# Groundwater Application Review Summary Form

Application # G- 18760

GW Reviewer Michael Thoma Date Review Completed: 06/15/2020

TO: Water Rights Section Date 6/15/2020  
 FROM: Groundwater Section M. Thoma  
 Reviewer's Name  
 SUBJECT: Application G- 18760 Supersedes review of \_\_\_\_\_  
 Date of Review(s) \_\_\_\_\_

**Thisis Time-Drawdown Worksheet** v.3.00

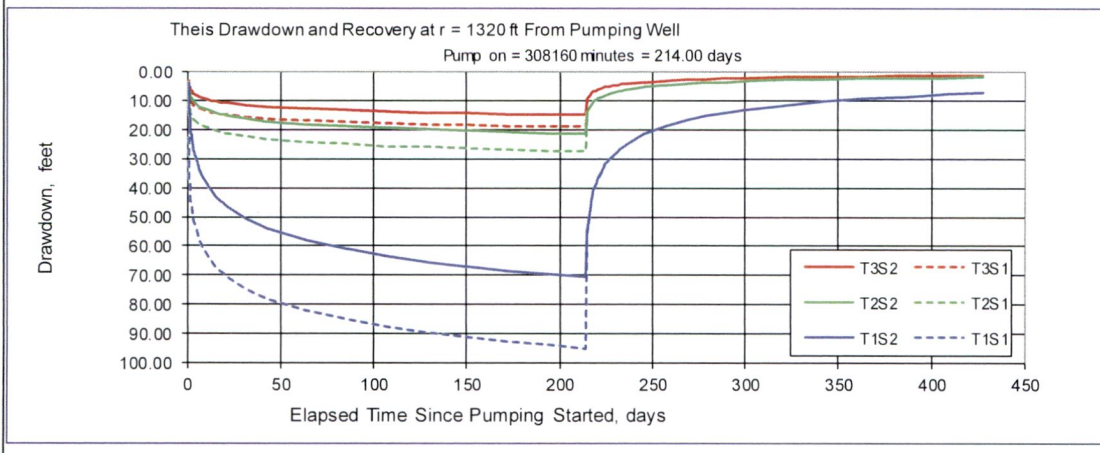
B3. **Groundwater availability remarks:** There is insufficient data to determine if the groundwater resource is over-appropriated but water-balance estimates from Gannett et al., (2007) suggest that the groundwater resource has been fully developed. The applicant’s proposed well is located within 1 mile of a densely-developed neighborhood (several 1-acre lots) where most of the taxlots that have been developed have a domestic well associated with them (nearly 40 wells have been drilled in the Section which are concentrated in the southern part near the proposed POA). Approximately 20 taxlots are within ¼ mile of the proposed POA. Many of the well logs for this area report total well depths around 100 to 150 feet and SWLs between 20 and 70 ft (the range of SWLs are more likely controlled by land surface elevation and not vertical changes in hydrogeologic characteristics). Hydrologic interference (drawdown) from the proposed use at neighborhood wells within ¼ mile may be over 20 ft by the end of the irrigation season (over 25% of customary aquifer thickness) which would cause injury to existing, domestic groundwater users. The well construction as proposed by the applicant would not likely eliminate interference to shallower domestic wells.

T1 S1	T1 S2	T2 S1	T2 S2	T3 S1	T3 S2
Max Drawdown at 214 d	95.10	70.84	27.43	21.36	19.00	14.95

76 PyHunt stream depletion analysis tool

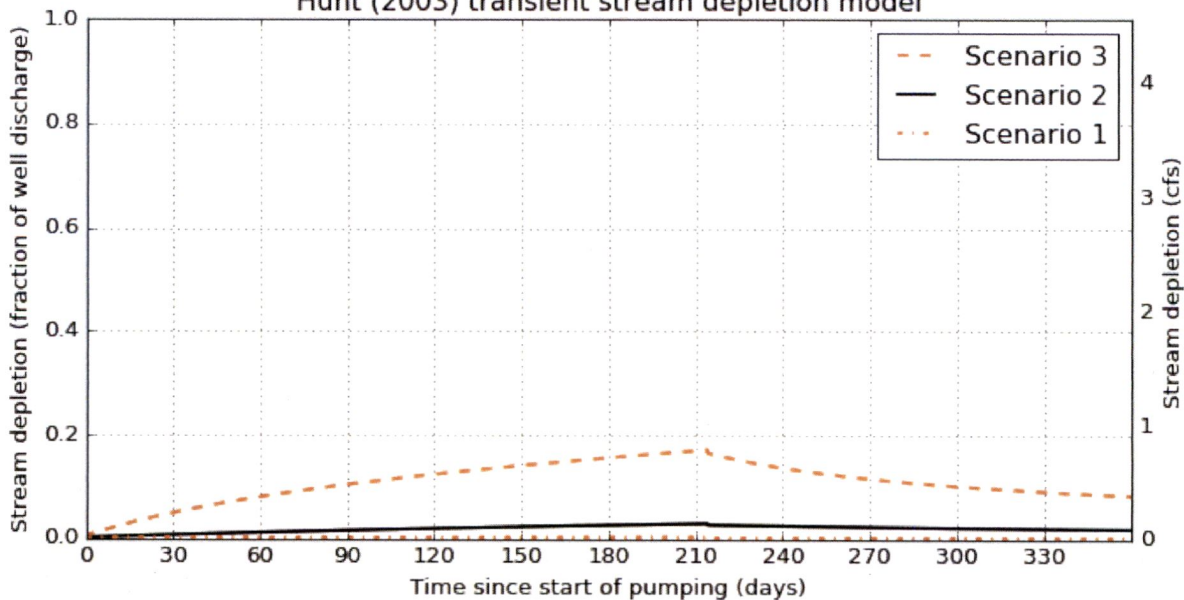
**Comments:** Instream Right KA 484 is located on Fourmile Cr. in the immediate vicinity and within 1 mile of the proposed POA and the proposed rate is greater than 1% of the instream water right. Stream-depletion was estimated using the Hunt-2003 stream-depletion model using parameter values derived from aquifer tests in the area, extracted from Gannett et al., (2012), or representative of the geologic material in the vicinity of the proposed POA.

C6. **SW / GW Remarks and Conditions:** The applicant's proposed POA would be producing from an aquifer that has been found to be hydraulically connected to surface water – specifically Fourmile Creek at a distance of less than 1 mile. The proposed maximum rate of appropriation is less than 1% of the pertinent adopted perennial streamflow for the WAB but is greater than 1% of the adopted instream water right for Fourmile Creek. Per OAR 690-009-0040(4) the POA is assumed to have the Potential for Substantial Interference.
